IFB No. IFB No. 22-05 Marsh School Playground Grading - Rebid

RE: **ADDENDUM NO. 1**

**TO THE BID SET AND SPECIFICATIONS FOR
Rockford Public Schools IFB No. 22-05 Marsh Playground**

PROJECT AND LOCATION:
MARSH PLAYGROUND GRADING PLAN
(IFB NO. 22-05)
ROCKFORD, ILLINOIS

PLAYGROUND SECTION
N.T.S.

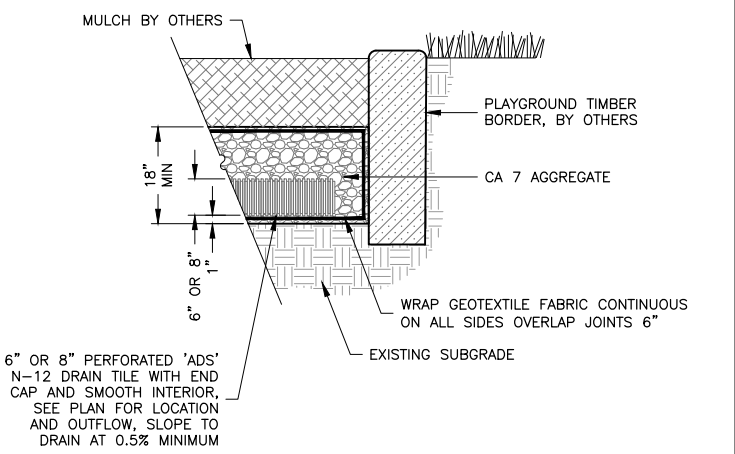
Question - If the base bid is chosen only (no aggregate chips and drain tile) will the imported fill scope be a larger quantity to conform to the provided design elevations, or are we leaving the grade low for others to install aggregate chips and drain tile on top of what we construct?

Answer - See revised details for Playground Section and Drain tile. CA-7 will now only be placed in trench for drain tile as part of Alternate one. There will be no CA-7 in base bid.
